Submission for Compliance with Approval Condition (g)

- the Submission of Fire Service Installations Proposal

Proposed Temporary Warehouse (excluding Dangerous Goods Godown) with
Ancillary Facilities for a Period of 3 Years and Filling of Land
in "Agriculture" Zone, Lots 1424 (Part), 1426 (Part), 1427 (Part) and 1428 (Part) in
D.D. 107 and Adjoining Government Land, Kam Tin, Yuen Long, New Territories
(Application No. A/YL-KTN/957)

<u>Appendix II – Response to the Previous Comments of Chief Engineer/Mainland North, Drainage Services Department (CE/MN, DSD)</u>

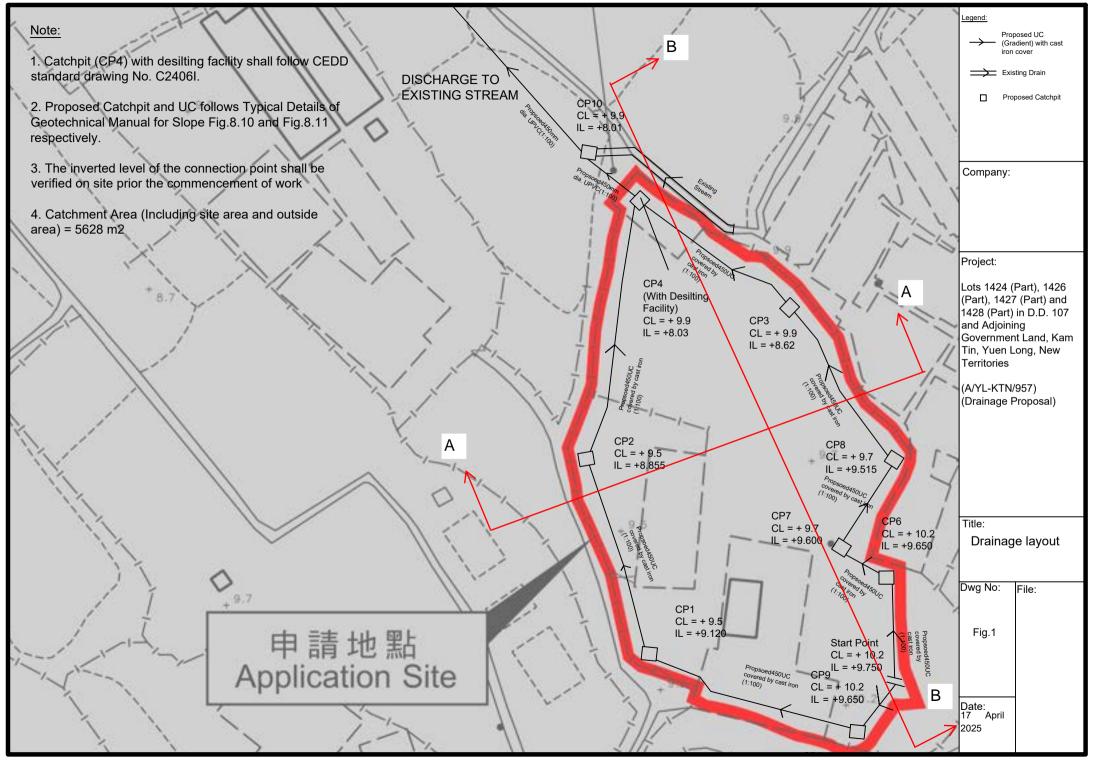
Com	Comments of the CE/MN, DSD						
(Con	tact Person:)						
(1)	Fig. 1 - There are two CP7.	It is revised accordingly (Annex I).					
(2)	Connection details - CP9 is not connecting to existing stream as shown in the drainage layout plan. All proposed invert levels should be given.	Connnection details of CP10 is revised and all proposed invert levels should be given (Annex I).

Figure 1 - Chart for the rapid design of U-shaped and half-round channels up to 600 mm

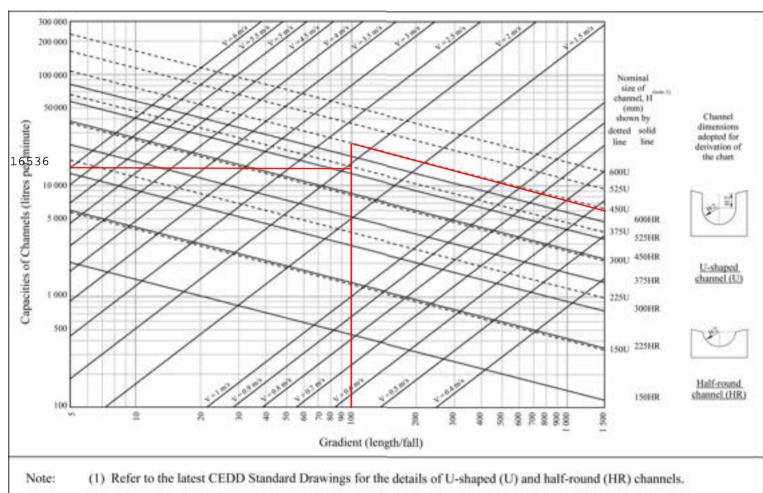
(3)	GEO TGN No. 42 - 375UC appears to be undersized in the chart. Please upgrade the UC size for conservative concern.	Proposed 375UC has been upgraded its size as 450UC (Annex I).

VIEW 2 FINAL DISCHARGE POINT

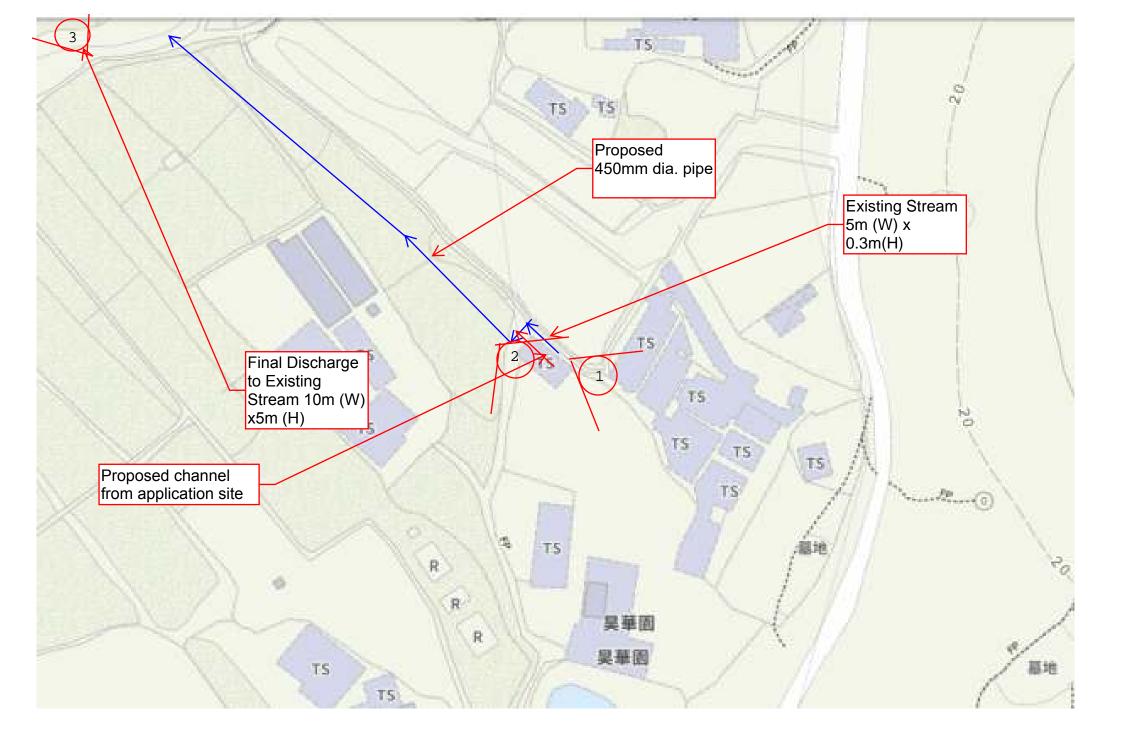
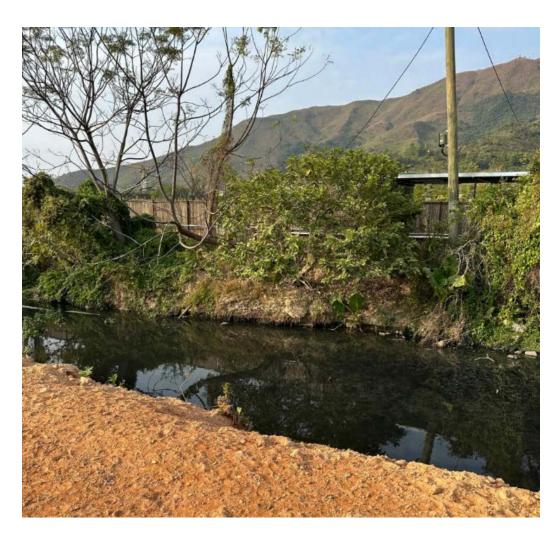
(4)	Please clarify the relationship between view 2 and view 3. It is noted that there are already few underground pipes in view 3, please clearly advise how the proposed discharge pipe would not affect the existing underground pipes.	Underground pipe will be reconstructed as 450mm dia. UPVC due to insufficient capacity of original pipe (Annex I).
